Model Error Resolution Document Complete only applicable items.	QA: QA Page 1 of 14	
INITIATION			
1. Originator: Ernest Hardin	2. Date: 02/29/2008	3. ERD No. MDL-NBS-HS-000001 ERD 01

4. Document Identifier: MDL-NBS-HS-000001 REV 05	5. Document Title: Drift-Scale THC Seepage Model		
6. Description of and Justification for Change (Identify applicable CRs and TBVs): <p>Introduction: This ERD documents qualification of three DTNs that are used as direct input to MDL-NBS-HS-000001 REV 05. These input data are tracked by TBVs 8868, 8869, and 8792: (DTNs: MO0009THRMODYN.001 [DIRS 152576], SN0002T0872799.009 [DIRS 153364], and SN9908T0872799.004 [DIRS 108437]). There are currently no CRs against MDL-NBS-HS-000001 REV 05.</p> <p>Changes:</p> <p>A. See Attachment 1 for qualification of input data tracked by TBVs 8868, 8869, and 8792.</p> <p>B. The higher temperature <i>log K</i> values (i.e., for temperatures greater than 100°C) for α-cristobalite and β-cristobalite in Tables C.4-2 and C.4-3, respectively, of the subject document (SNL 2007 [DIRS 177404]), were obtained from DTN: MO0008THRMODYN.000 [DIRS 152576], file: <i>data0.com</i>.</p> <p>C. Delete the following two sentences from line

Figure 1. Comparison of Effective Thermal Conductivity Data Used in the Drift-Scale THC Seepage Model, with Corroborating Data

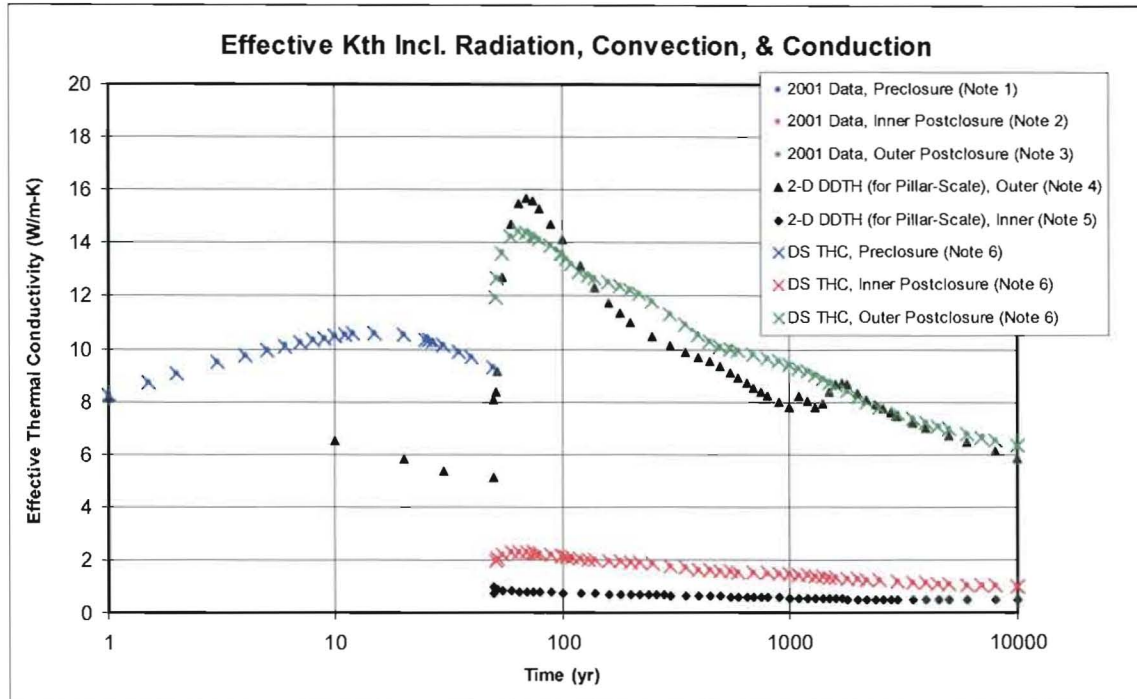
Both the data to be qualified (DS THC in Figure 1) and the independent, qualified data (2-D DDTH) are subject to the condition identified by Francis et al. (2003 [DIRS 164602], Section 2.8) that local variation in convective heat transfer causes variability (i.e., θ -dependence) in heat transfer around the periphery of the drift wall. The differences between the DS THC and 2-D DDTH histories are generally less than, or comparable to, the θ -dependent variation (Francis et al. 2003 [DIRS 164602], Figure 14 through 19).

Accordingly, the subject effective Kth data are reasonably close to the qualified data, and both are subject to the limitation that they be used to simulate average conditions (e.g., periphery-averaged drift wall, drip shield, or waste package temperatures). There is no

6. Source data to be qualified: DTN: SN0002T0872799.009 [DIRS 153364], File: *tough2-input_noBF.txt*, in archive *effKth_noBF.ZIP*.
7. For the inner values, the differences between data set that was used and the qualified data are larger than for the outer values. However, since EBS indrift temperatures (waste package and drip shield) are not being developed in this AMR, and the driftwall temperatures are not impacted by these effective thermal conductivities, the differences are not significant.

In summary, this evaluation shows that the effective Kth data to be qualified are similar to other, qualified data, and the differences are insignificant with respect to the intended use of the THC seepage model. This conclusion is supported by inference, from comparison of the differences to other uncertainties involved with simulating temperature and other conditions within the emplacement drifts.
